Re: Addendum to Environmental Impact Statement for DA 8/2018/539/1

The Environmental Impact Statement (EIS) for DA 8/2018/539/1 was lodged to Cessnock City Council on 22/08/2018 for 39 industrial lots, to be delivered in six stages and one environmental conservation lot, as shown on the Subdivision Plan prepared by ADW Johnson dated 14/08/2018.

The purpose of the following letter is to provide an addendum to the forementioned EIS, to replace the Subdivision Plan to the following:

Figure 1 Proposed Subdivision Plan prepared by ADW Johnson dated 07/10/2021

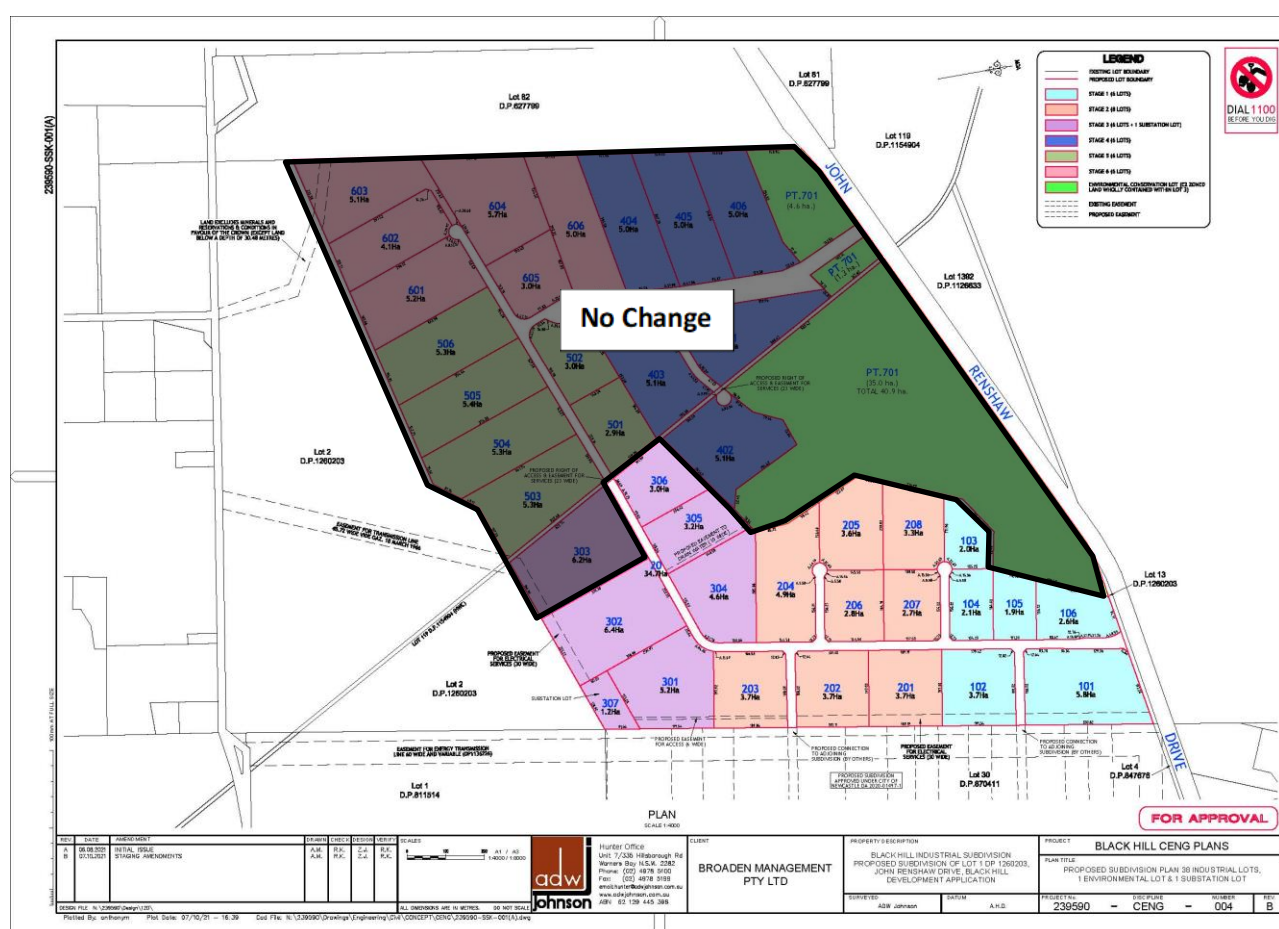
Since the EIS has been submitted, DA2020/01497 has been approved on Lot 30 DP 870411, which adjoins the subject site to the east. This approved DA included an access onto John Renshaw approximately 140 metres to the east of the common boundary between Lot 30 and the subject site. As a result, the location of the access to the subject site was required to be moved to accommodate the approved intersection on Lot 30.

- Proposed Subdivision Plan 38 Industrial Lots, 1 Environmental Lot & 1 Substation Lot prepared by ADW Johnson (reference 239590, no. 004, rev. B, dated 7 October 2021).

It is important to note the development footprint and Stages 4, 5, 6, Environmental Conservation Lot and part Stage 3 have not changed.

- The eastern most access moved approximately 230 metres west.
- Reconfiguration of Lots in Stages 1, 2 and part Stage 3 to facilitate the updated access. A comparison of the updated lot sizes are shown in Table 1.
- Amended Landscape Plan.
